COST CHANGE DIRECTIVE (CCD) 001

RE: MERCY HOSPITAL BERRYVILLE
RTU – 11 REPLACEMENT
Berryville, Arkansas

A/E Project Number: 2025-020

- 2: Drawing changes are resultant of unforeseen physical limitations for supply air duct routing as presented by Nabholz Construction via RFI #01 dated June 30th, 2026 and subsequent site walk.
- 3: Insert the attached revised Drawings issued with this CCD:

DEMOLITION AND CEILING PLANS

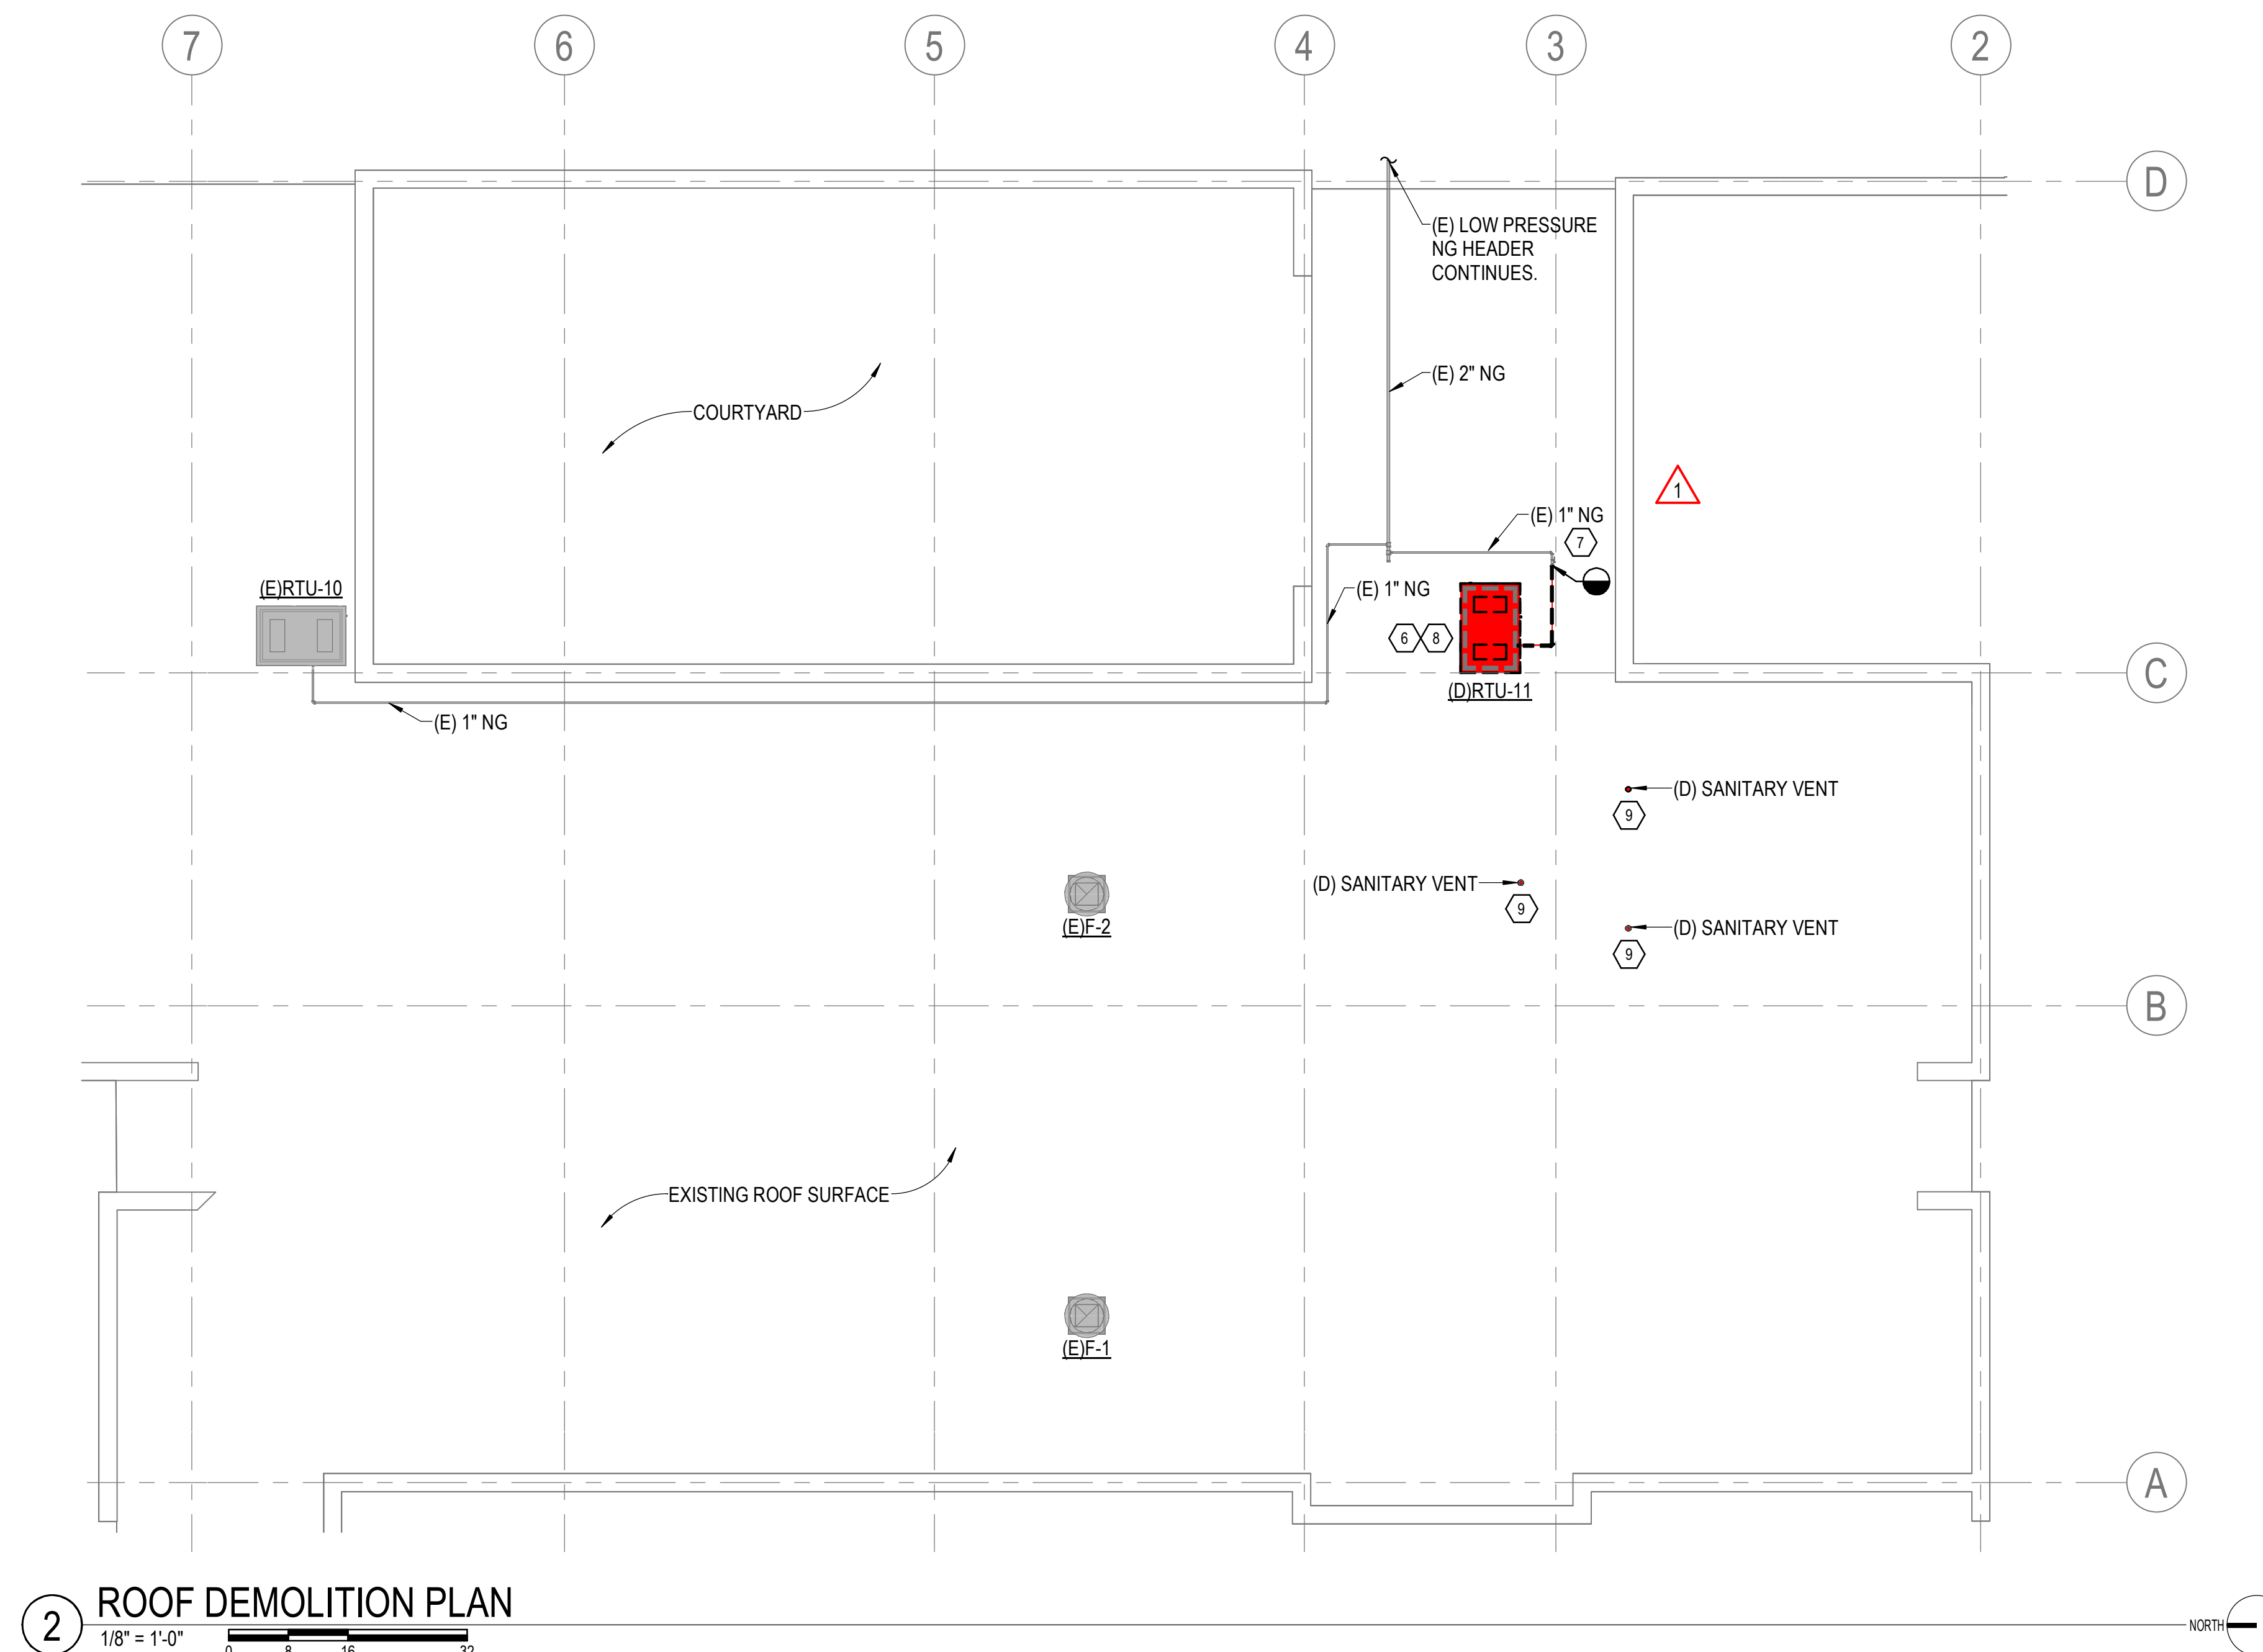
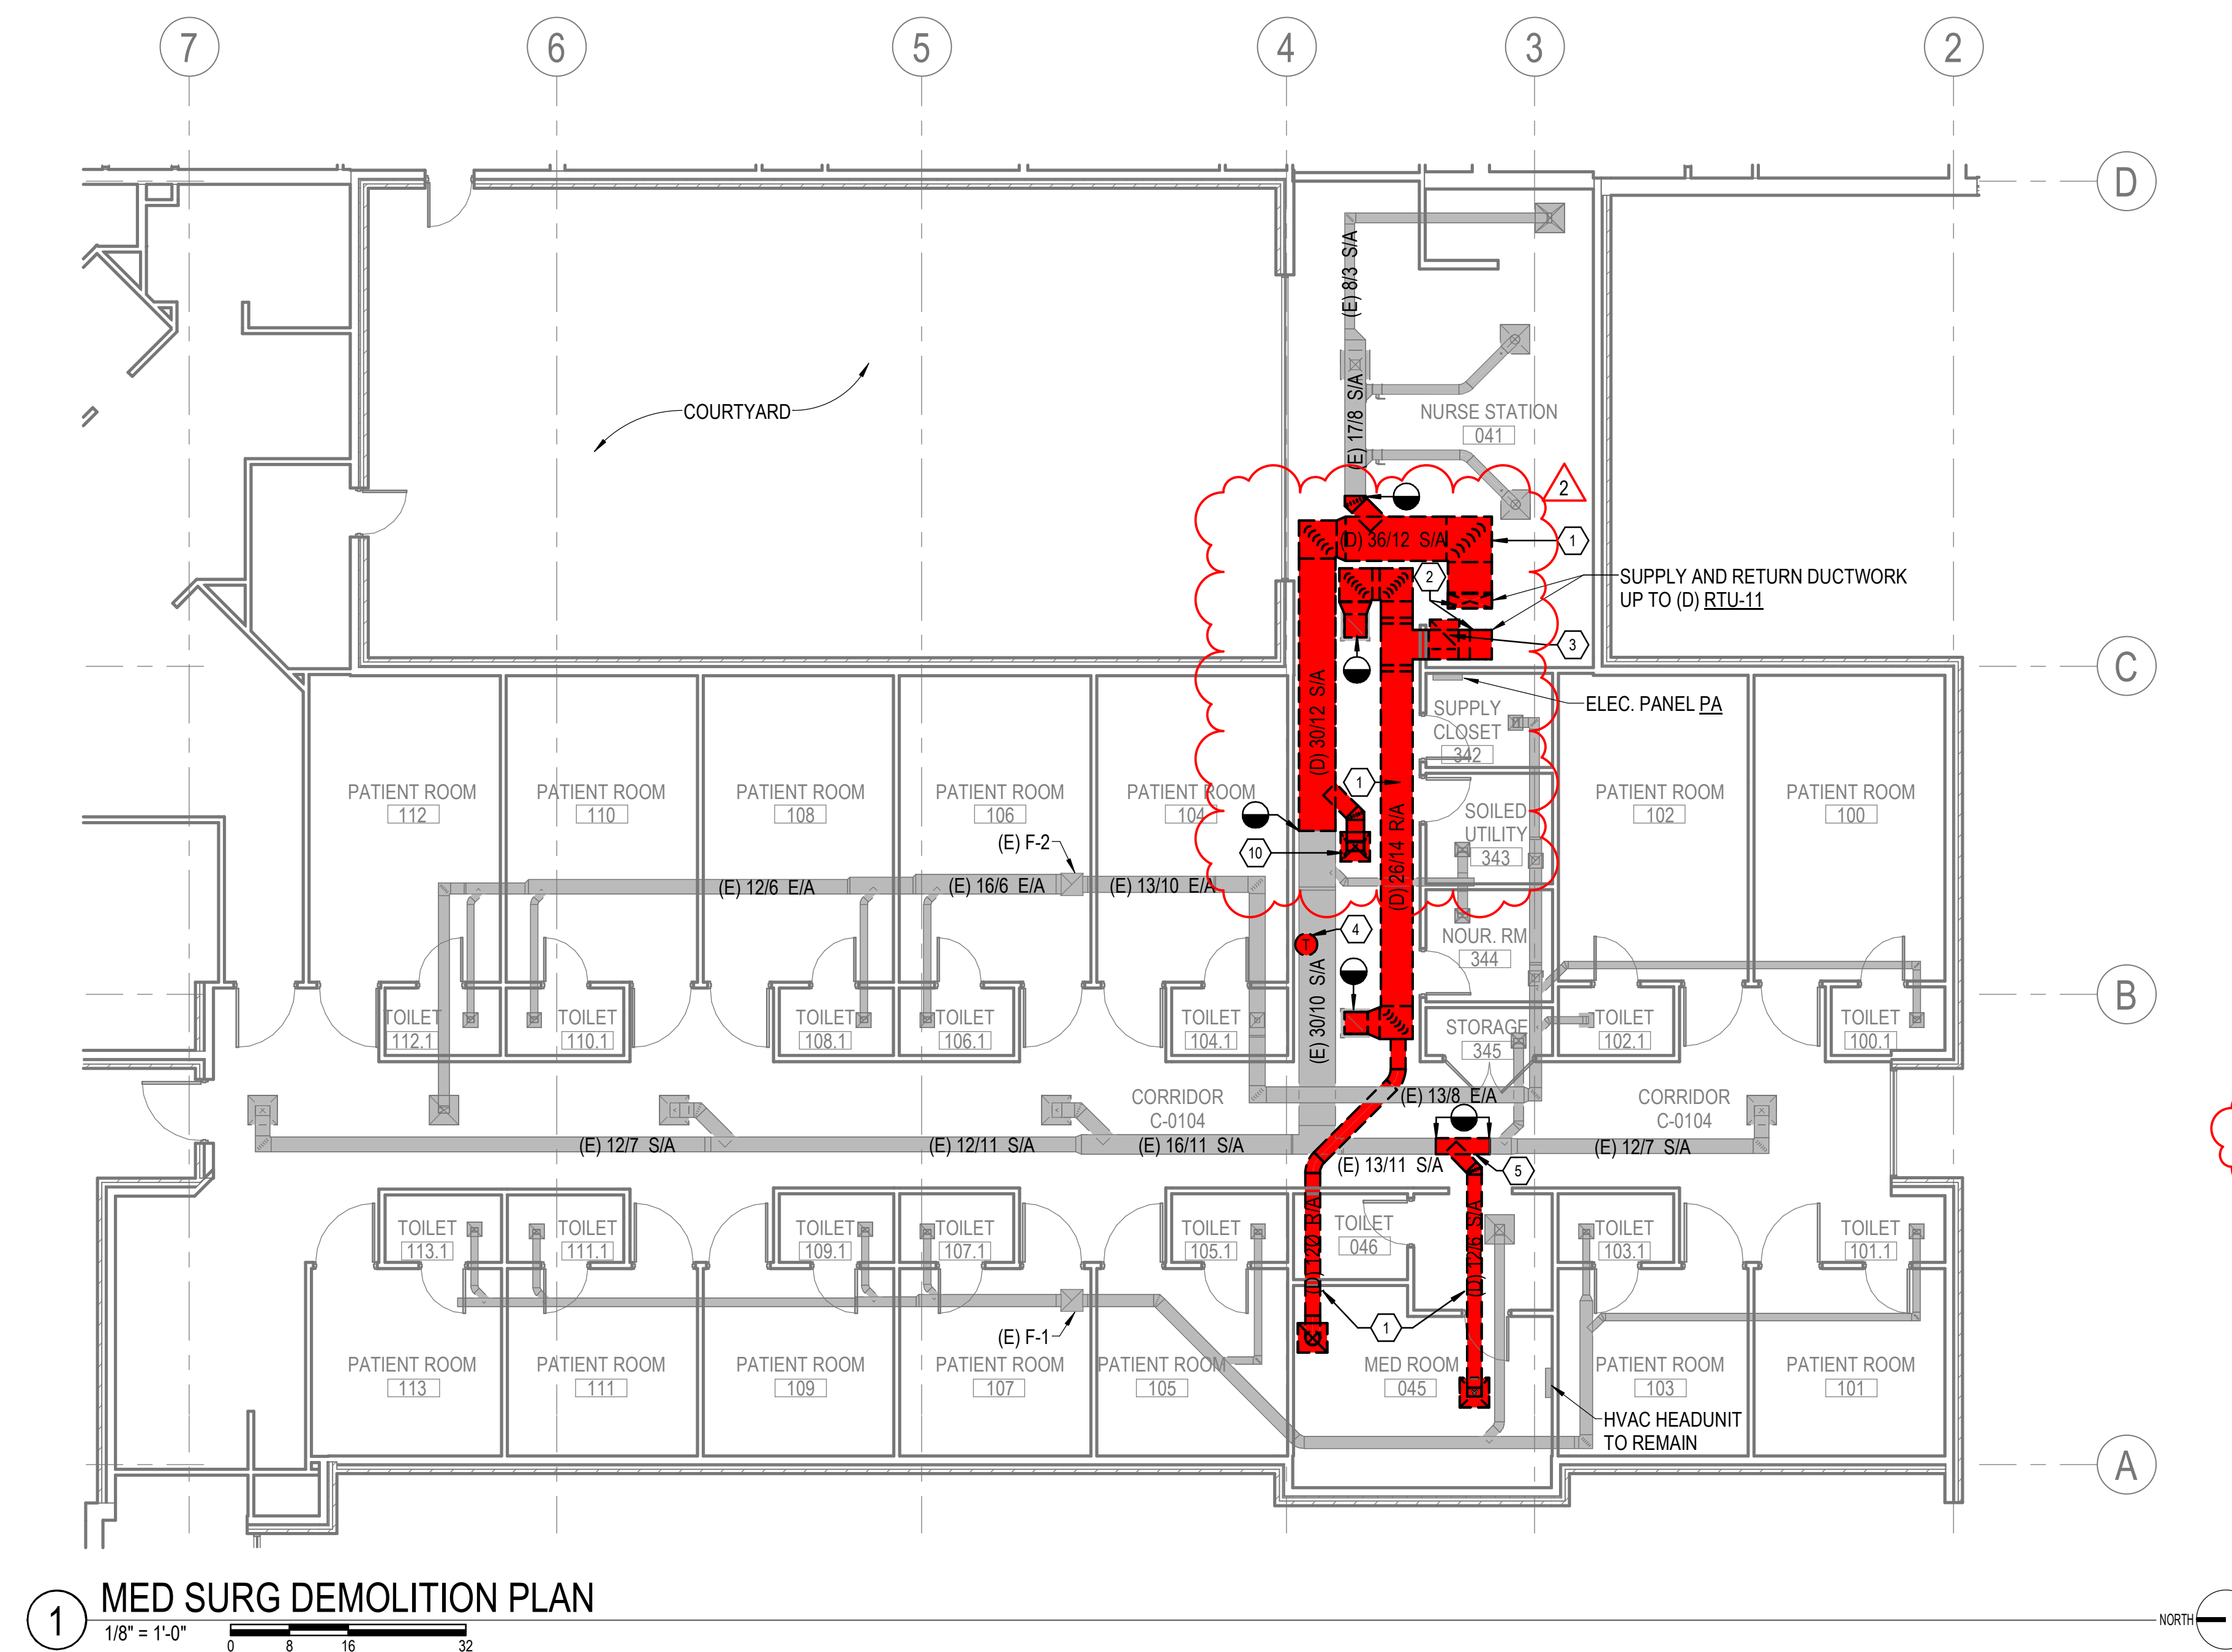
- ① REMOVE DUCTWORK AND INSULATION TO LOCATION INDICATED. PREPARE DUCTWORK CONNECTION TO BE REUSED FOR CONNECTION IN NEW WORK. FIELD VERIFY ACTUAL ROUTING AND CONNECTION POINT.

- ② DEMOLISH DUCTWORK, INSULATION, AND DUCT TRANSITION UP TO (D)RTU-11. DEMOLISH EXISTING THERMOSTAT.
- ③ DEMOLISH CEILING AIR DEVICE AND DUCTWORK BACK TO LOCATION INDICATED.

- ④ DEMOLISH WALL MOUNTED THERMOSTAT AND THERMOSTAT WIRE BACK TO UNIT.
- ⑤ DEMOLISH PORTION OF RECTANGULAR SUPPLY DUCTWORK AND PREPARE REMAINING DUCTWORK FOR RECONNECTION IN NEW WORK.

- ⑩ REMOVE EXISTING SUPPLY AIR DEVICE AND STORE FOR REINSTALLATION IN NEW LOCATION IN NEW WORK.

ENLARGED MED SURG
FLOOR PLAN

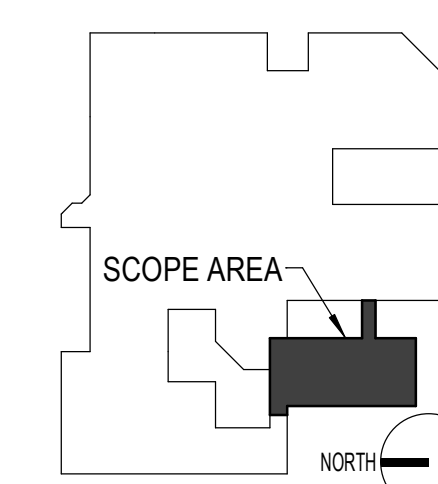
- ② TRANSITION 36/14 RECTANGULAR DUCT UP TO NEW RTU-11 SUPPLY AIR CONNECTION WITH SMOOTH RADIUS FITTINGS.
- ③ TRANSITION 24/16 RECTANGULAR DUCT UP TO NEW RTU-11 RETURN AIR CONNECTION WITH SMOOTH RADIUS FITTINGS.

- ⑨ EXISTING SPLIT A/C UNIT TO REMAIN IN OPERATION FOR ROOM TEMPERATURE CONTROL.
- ⑩ DIVIDED FLOW BULL HEADED TEE FITTING WITH TURNING VANS. ②
- ⑪ INSTALL RELOCATED AIR DEVICE IN CEILING IN NEW LOCATION.
